**Negotiated Decision Notice**

Application Number:	DA/4426
Street Address:	23 - 26 Webber Esplanade, Cooktown 4895
Real Property Description:	Lot 0 on SP188678 Lot 1 on SP188678 Lot 2 on SP188678 Lot 3 on SP188678 Lot 4 on SP188678
Planning Scheme:	Cook Shire Council Planning Scheme 2017 v2

Development Permit for Reconfiguration of a Lot Four (4) Lots and Common Property into Four (4) Lots and Access and Services Easement into Four (4) Lots.

**PLAN OF DEVELOPMENT**  
**Proposed Subdivision of**  
**Lots 1-4 & CP on SP188678**

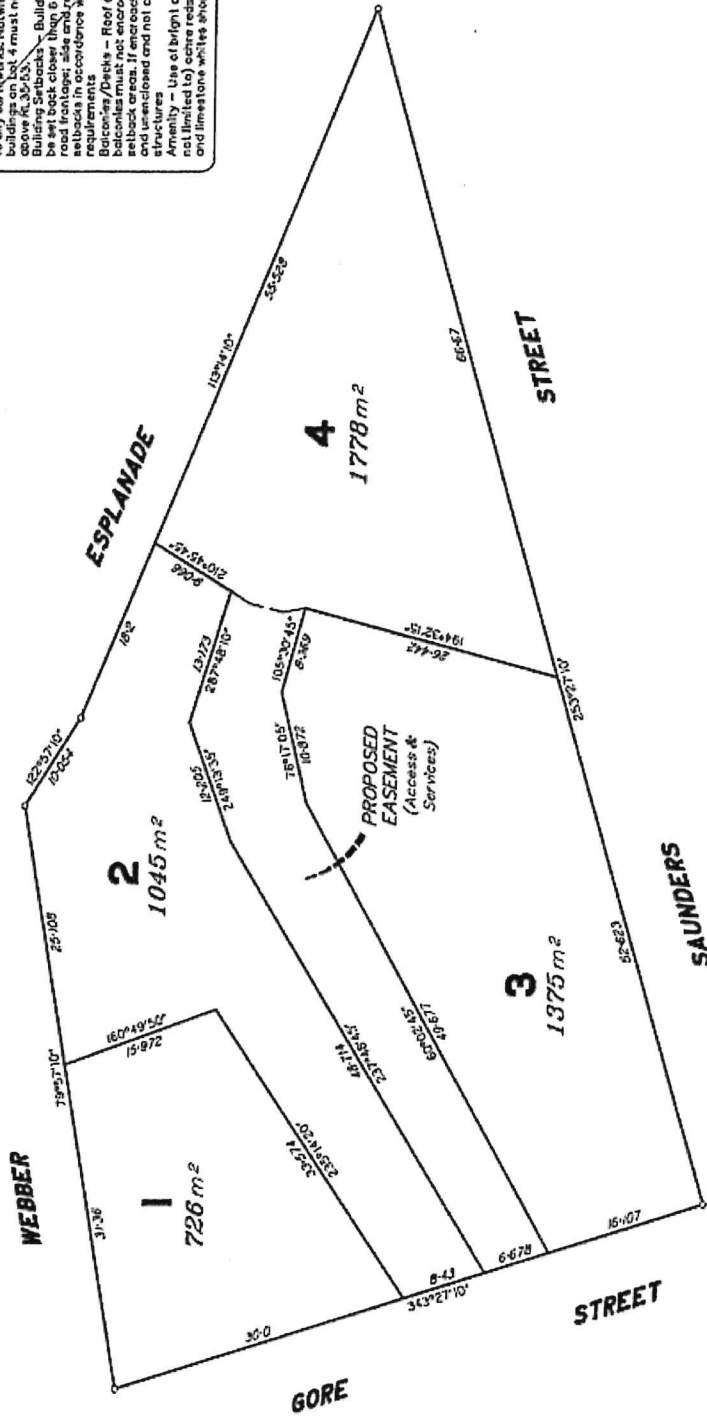
2. The proposed lot layout must be amended to ensure all services and retaining wall structures are wholly contained within the proposed lot boundaries as follows:

- (a) amendment to the boundary of proposed Lot 1 in the south-eastern corner to ensure the retaining wall is wholly contained within proposed Lot 2;

- (b) amendment to the boundary of proposed Lot 3 to ensure the retaining wall in the access handle of proposed Lot 4 is wholly contained within proposed Lot 3;

- (c) amendment to the boundary of proposed Lot 3 to ensure existing stormwater infrastructure is wholly contained within proposed Lot 3; and
  - (d) amendment to the boundary of proposed Lot 4 to ensure the retaining wall is wholly contained within proposed Lot 3.

3. The Development Controls identified on the approved plan of development (Murray & Associates, Drawing No. 7967-23343, dated 10/08/2021) do not form part of this approval.
